PROJECT NO. 278-91 (B91-200)

Water Control Structure at
PROJECT Salt Bayou

Review of Aviles Report
on Salt Bayou Water Control Structure

BORING 91-200

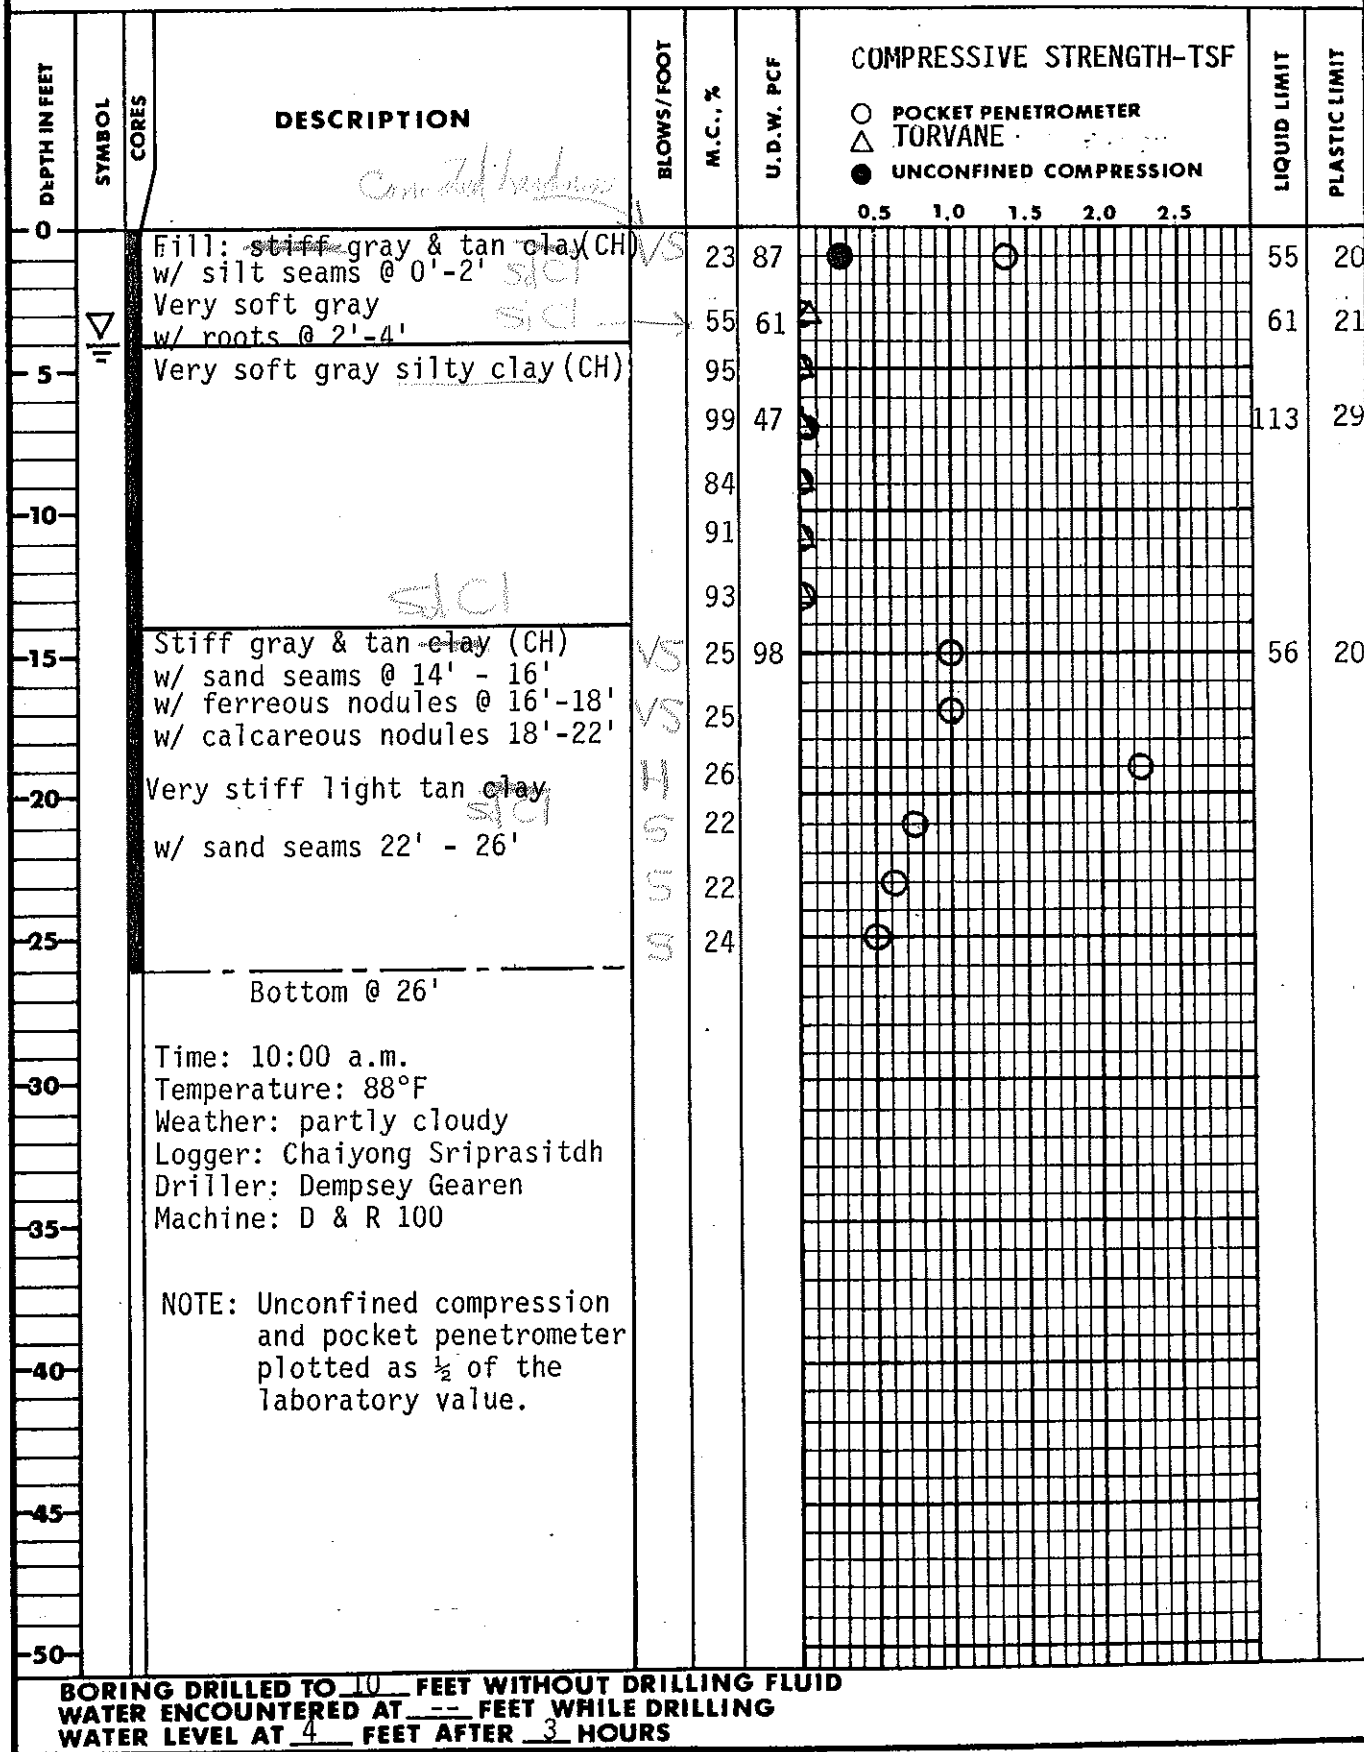
2. A comparison of the plots of pocket penetrometer readings with those shown on the driller's log appears to indicate that most if not all of the field readings were used on the plots. The contracts states: "The consistency of undisturbed cohesive materials shall be determined in the laboratory by taking pocket penetrometer readings in accordance with procedures outlined in Paragraph 8.6." Were pocket penetrometer readings taken in the laboratory?

3. A number of the torvane readings shown on the plots indicate no shear strength. What in fact were the torvane readings? A tabulation of the torvane readings should have been presented on the Summary of Laboratory Test Data.
